Form C-103
 June 19, 2008

McElvain proposes to P&A the referenced well per the attached procedure.

PLUG AND ABANDONMENT PROCEDURE

Lim #1

Lim #1 Proposed P&A

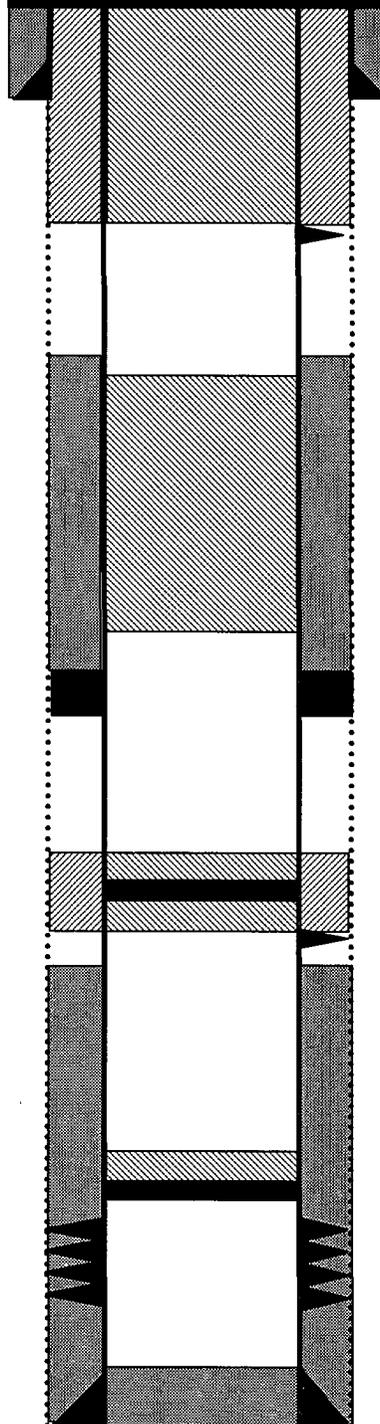
Conditions of Approval (if any): PLACE A PLUG ACROSS THE CHACRA FORMATION INSIDE + OUTSIDE CASING PER INSTRUCTIONS ON PAGE #2

** CHACEA PLUG
2900' - 2800'*

Isolated casing leaks from 3560' to 3591' and 568' - 599' (2009) *INSIDE + OUTSIDE*

** CHACRA PLUG - 2900' - 2800' INSIDE AND OUTSIDE CASING.*
6. **Plug #3 (Pictured Cliffs Fruitland, Kirtland and Ojo Alamo tops, 2065' – 1487')**: Mix and pump 48 sxs cement and spot a balanced inside casing to cover through the Ojo Alamo top. TOH with tubing.
